# AIR CHIEF

## SERVICE DATA

C14N-2

### PN — C14N and MN — C14N

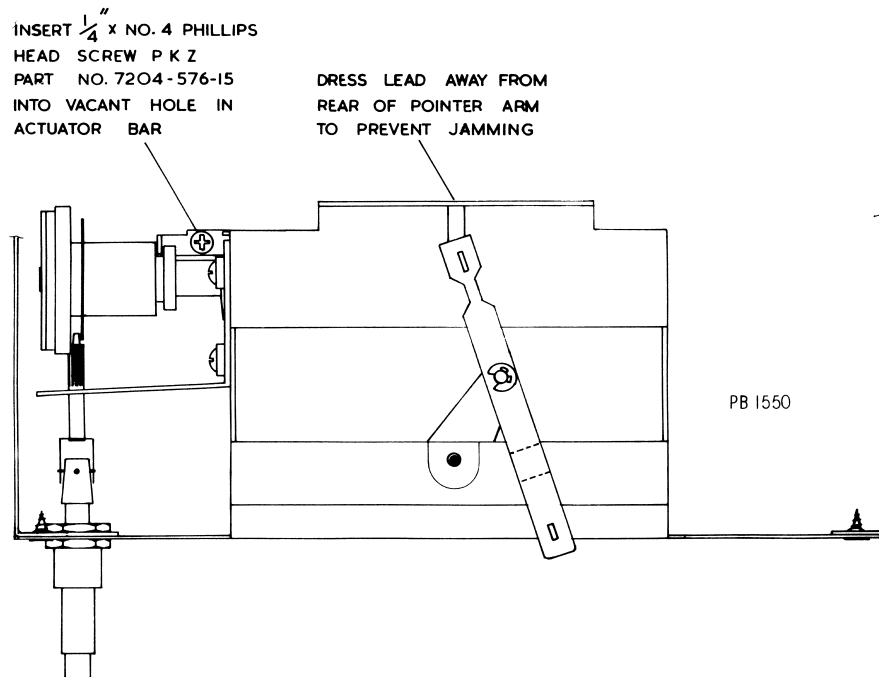
### .1uF CERAMIC CAPACITOR CIRCUIT NO.32

To simplify the component layout this capacitor is being wired on to the underside of the circuit board.

### ACTUATOR BAR - PUSH BUTTON TUNER

To prevent the actuator bar from moving out of position, a screw is now being inserted into the bar at the end nearest the clutch.

A  $\frac{1}{4}$ " x No.4 self tapping screw is to be inserted into the vacant hole at this location during service.
